**CITY OF SUNNYVALE
CITY COUNCIL JOINT STUDY SESSION SUMMARY WITH
PLANNING COMMISSION
DISCUSSION OF POSSIBLE AMENDMENT TO DOWNTOWN SPECIFIC PLAN
RELATING TO STREET DESIGN FOR MATHILDA AVENUE BETWEEN EL CAMINO
REAL AND EVELYN AVENUE
JULY 23, 2013**

A RESOLUTION OF THE CITY COUNCIL OF THE CITY OF SUNNYVALE AMENDING THE DOWNTOWN SPECIFIC PLAN TO AMEND THE STREETScape AND DESIGN STANDARDS AND ELIMINATE THE REQUIRED RESIDENTIAL FRONTAGE ROAD ALONG THE WEST SIDE OF SOUTH MATHILDA AVENUE (WEST OF MATHILDA DISTRICT BLOCKS 14, 15 AND 16).

Attachment 5
No Frontage Road Alternative

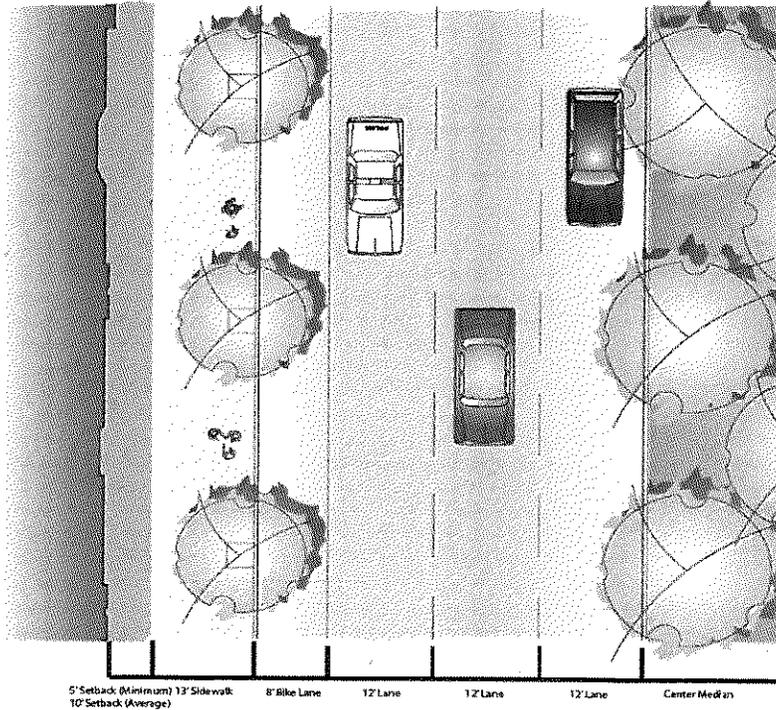
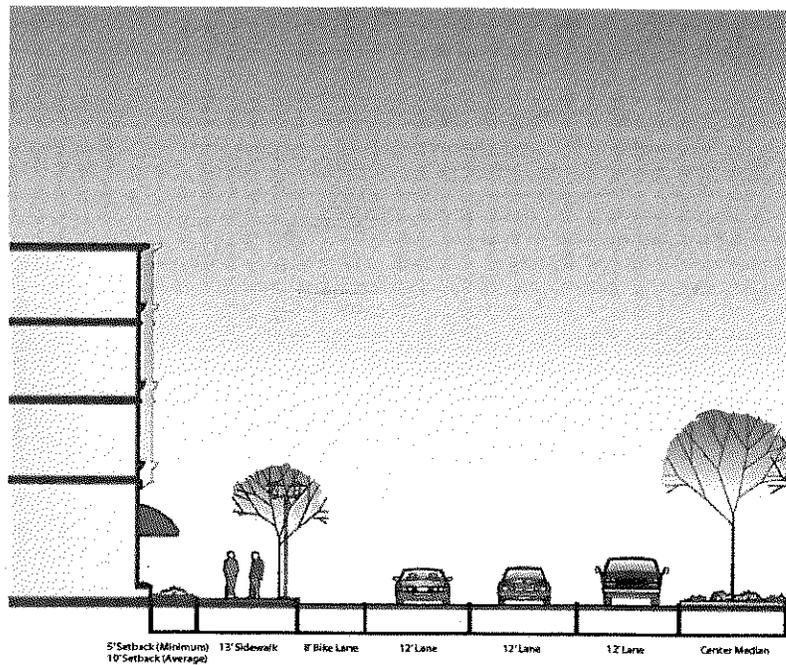
- What was the original intent on requiring the carriage road?
- Carriage road could provide a "grander" interface with Mathilda
- If there is no carriage road could there be another way to configure the additional 18 feet of right-of-way?

- What are the traffic and access issues for vehicles needing to make U-turns?
- Is parking required on Mathilda?
- From an urban design standpoint it seems that Mathilda without the carriage road provides a better visual connection between the two sides of street.

- At this point it appears there are more benefits without the carriage road
- Clarify the allowable density in the blocks (*note this was later clarified in the July 25, 2013 City Manager Bi-Weekly Report*)

EXHIBIT "A"
AMENDED STREETSCAPE
WEST OF MATHILDA DISTRICT
BLOCK 14, 15 AND 16

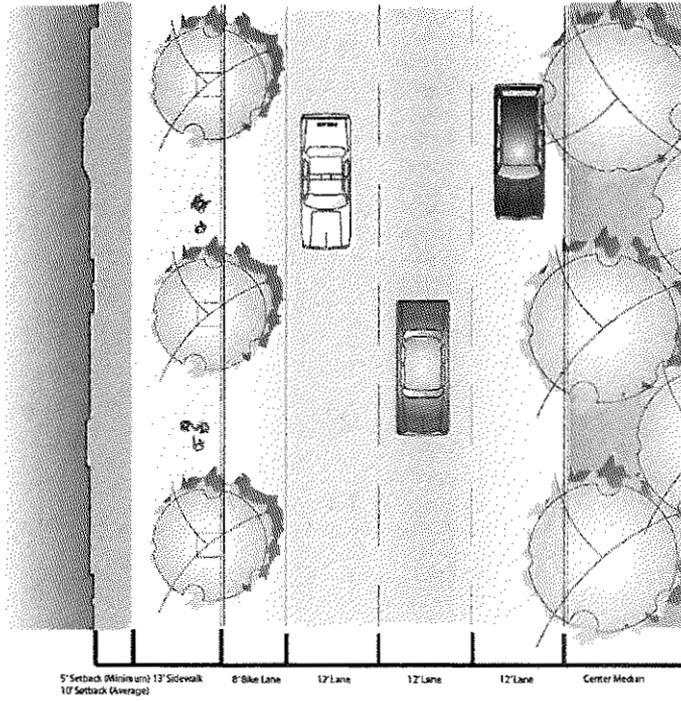
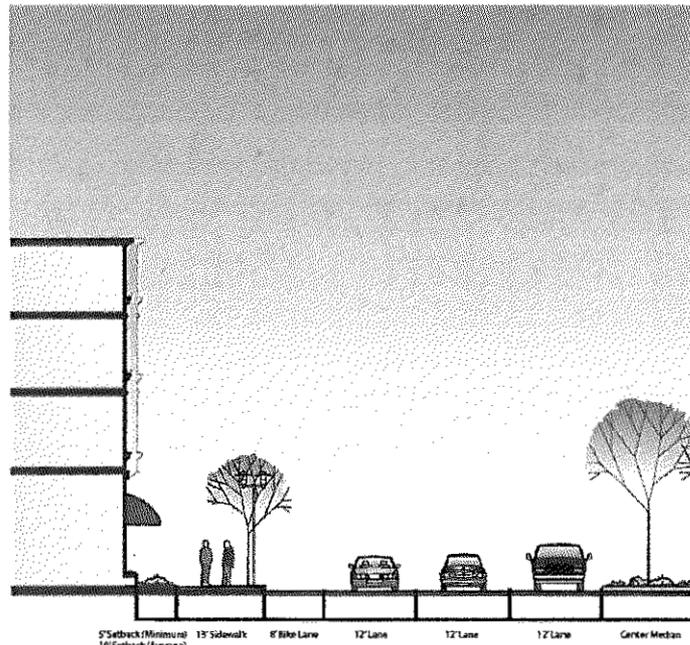
AMEND THE STREETScape DESIGN STANDARDS AND RELATED SECTIONS OF THE DSP TO ELIMINATE THE REQUIREMENT FOR A FRONTAGE ROAD IN THE WEST OF MATHILDA DISTRICT (BLOCKS 14, 15 AND 16); and

ELIMINATE THE REQUIRED 33-FOOT WIDE DEDICATION; and

ADOPT A MINIMUM BUILDING SETBACK OF FIVE (5) FEET AND AN AVERAGE OF TEN (10) FEET ON THE WEST SIDE OF MATHILDA AVENUE; and

ADOPT A NEW CROSS SECTION FOR THE PUBLIC RIGHT-OF-WAY FOR THE WEST SIDE OF MATHILDA AVENUE AS SHOWN IN EXHIBIT “A”; and
